DANCING LAKE SUBDIVISION

The plat illustrates the proposed 11 lot, $6\pm$ acre subdivision which is located on the South side of Ben Hamilton Road, $\frac{1}{2}$ mile \pm East of March Road. The site is served by individual wells and septic systems.

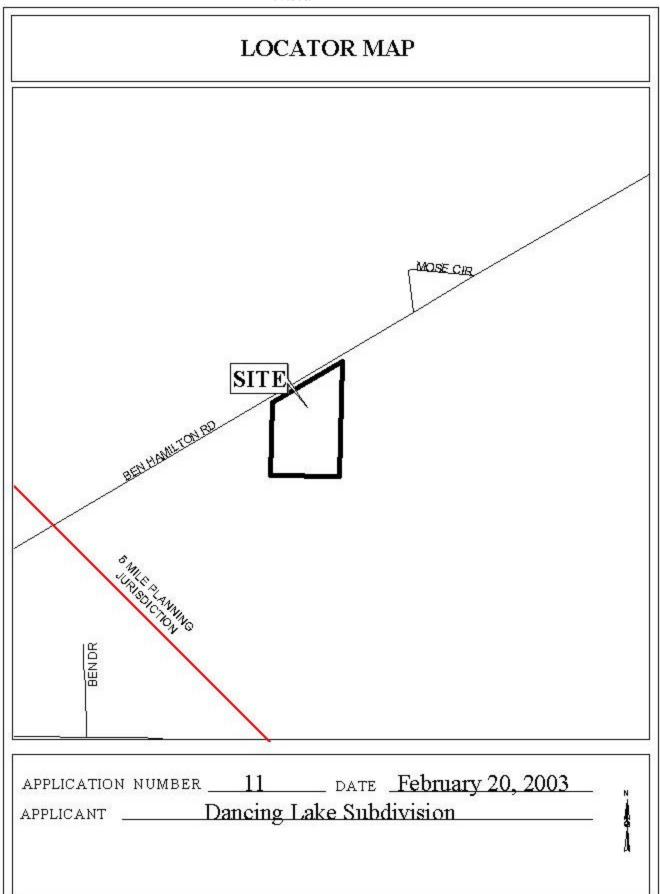
The site consists of 11 lots, with a new street. The new street simply "dead ends"; however, a cul de sac should be provided. Additionally, this new street must be dedicated and constructed to County standards. Moreover, as a means of access management, Lots and 1 and 11 should be denied direct access to Ben Hamilton Road.

As outlined above, the site will be served by individual wells and septic systems, and the Subdivision Regulations require a minimum area of 20,000 square feet per lot. Lots 2-5, and 8-10, contain 19,788 square feet. Additionally, when a full cul de sac is provided, Lots 6 and 7 have less than 20,000 square feet, thus this application should be heldover to allow the applicant to submit a revised plat, addressing these issues.

Based upon the preceding, this application is recommended for holdover to allow the applicant to submit a revised plat addressing the following concerns: 1) provision of a cul de sac; and 2) provision of 20,000 square feet per lot. The revised plat should be submitted by February 28, 2003.

At the time of mailout, no additional information had been submitted; therefore this application is recommended for denial for the following reasons: 1) lack of an adequate turn around at the end of the street; and 2) lack of adequate area for all lots (20,000 square feet per lot is required).
